Parking Garage. Levels Cumberland AVE. Top Deck Lighting

Cumberland Avenue Parking Garage Site Plan - August Corp.

#### CUMBERLAND AVENUE GARAGE Public Hearing July 9, 1996

# Cumberland Avenue Garage Site Plan Summary of Planning Board Motion to Approve, July 9, 1996 With Excerpts from the Record Re: Conditions of Approval

20

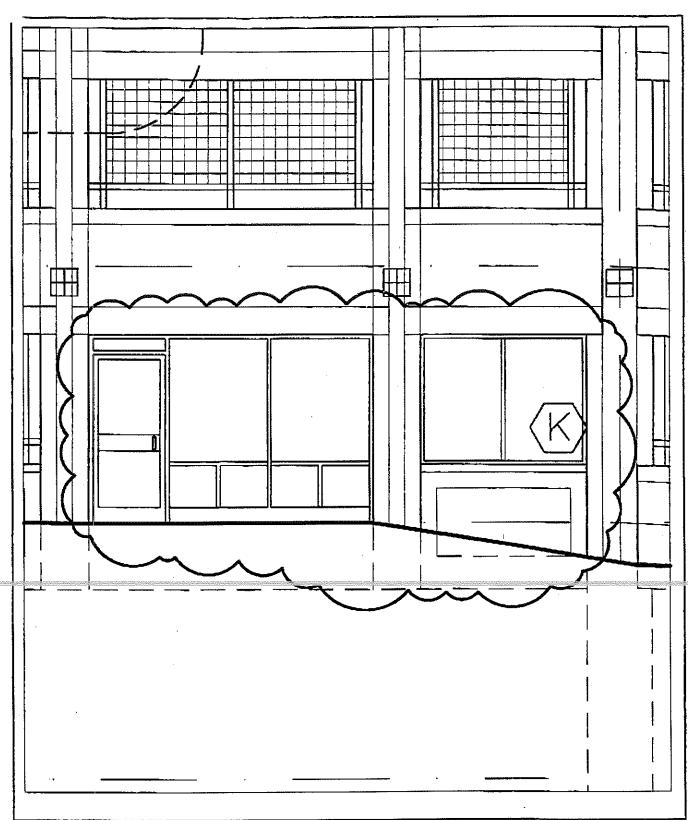
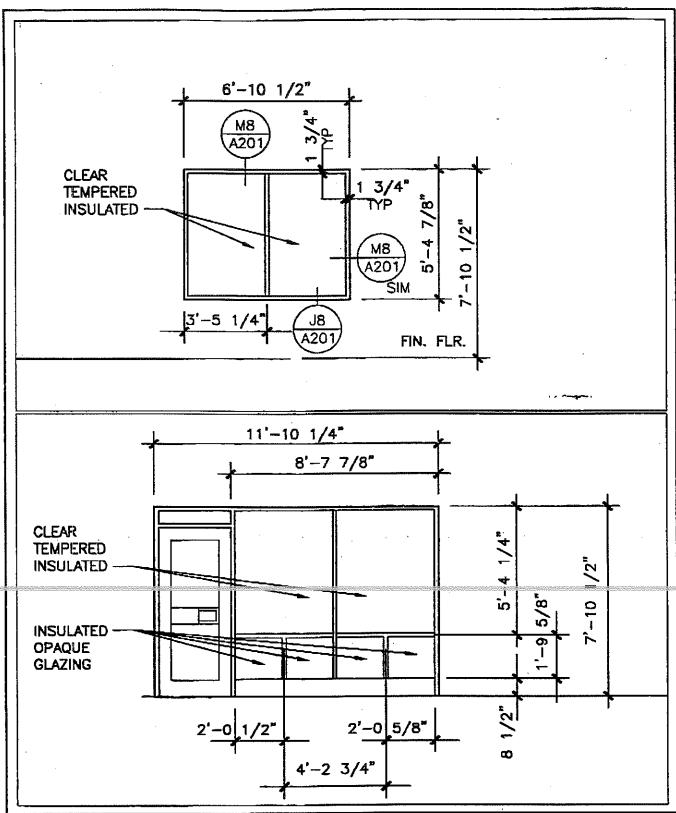
Revise the Elm street elevation on A301 and the storefront details on A201 per the following sk's 20 and 20A.

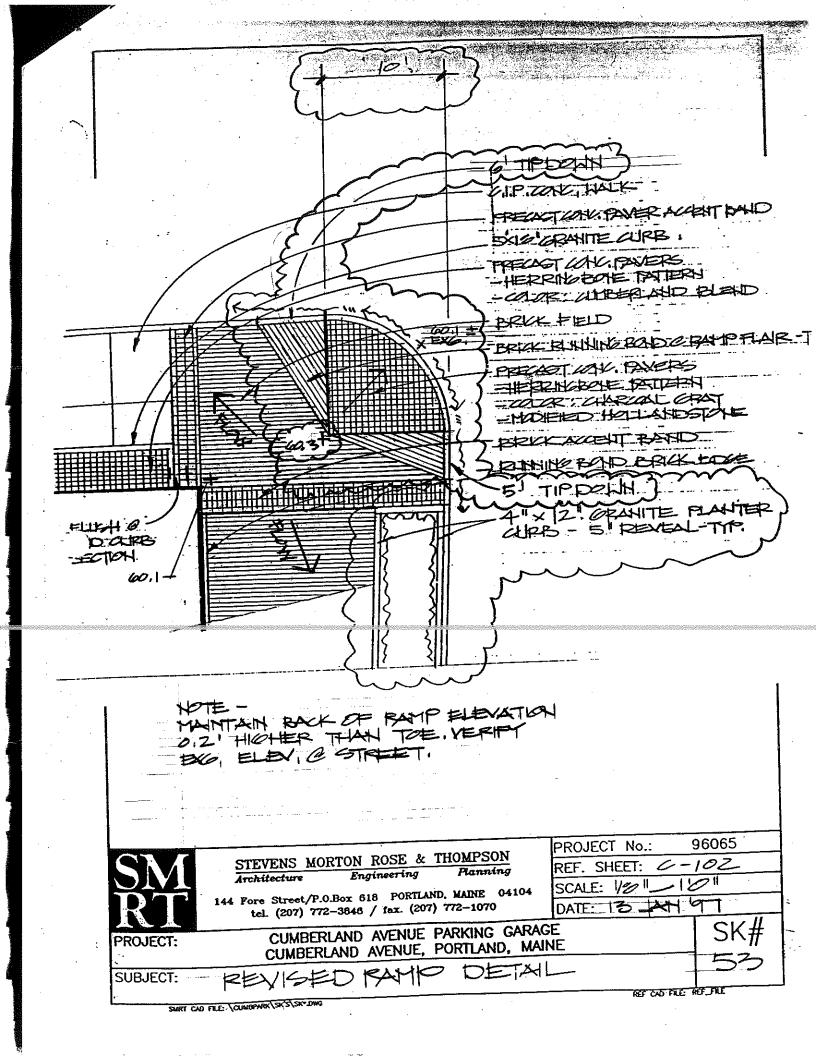
Provide handicapped access ramp at the corner of Cumberland Ave. and Elm Street per the attached SK\_53 - "Revised ramp detail".
